Preliminary Plat Petition No. 20-04PP

Owner: Border and Jacaranda Holdings, LLC
Agent: Jeffery A. Boone, Esq.

Petition Number:	20-04PP
Address:	Laurel Road
Request:	Platting a 126-unit townhouse subdivision with amenity area.
Owners:	Border and Jacaranda Holdings, LLC
Agent:	Chris Fisher, P.E., Clearview Land Design
Parcel IDs:	0389-00-1001 & 0389-00-1000
Property Size:	35.52 ± acres
Future Land Use:	Mixed Use Residential (MUR)
Zoning:	Planned Unit Development (PUD)
Comprehensive Plan Neighborhood:	Northeast Neighborhood
Associated Petitions:	19-41RZ (Milano PUD Amendment)

FIORE
(F.K.A. CIELO PH. 2)

MASTER SITE PLAN

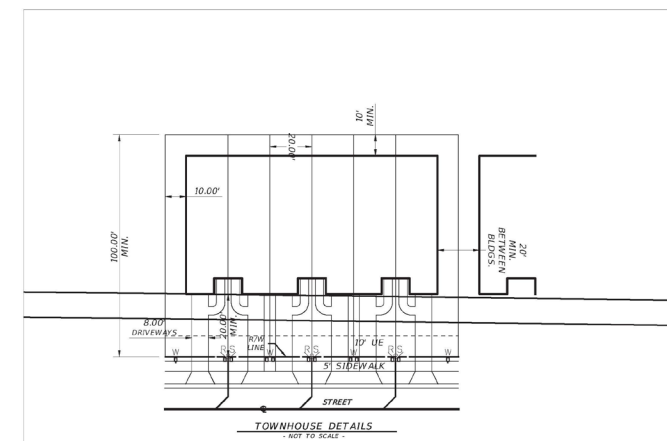
- Applicant notes consistency with Land Use Element and Northeast Neighborhood Element strategies for Mixed Use Residential Development
 - Strategy LU 1.2.14 - Mixed Use Development Connectivity
 - Satisfied through the provision of land for a multi-use recreational trail (MURT) along Laurel Road*
- *Correction to staff report: 12' of land will be provided for a MURT, though the sidewalk constructed through this plat will be a typical 5' sidewalk

- Limited access gates allowed per section F.3 of the PUD (roadways)
- Conforms to approved buffers Type B - West Property Line (no FPL easement) and Type C - Laurel and Border Road Typical (with FPL conflict).

- One modification to driveway standards is proposed through 19-41RZ to reduce the required minimum distance from the edge of pavement of two intersecting streets from 40 feet to 30 feet (Sec. 86-423(b)).
- Note that landscape plans are required as part of a preliminary plat application, but there are no general code standards that apply to the provided plan
 - Also no requirements for street trees or entryway plantings, and buffer landscaping is regulated through the PUD
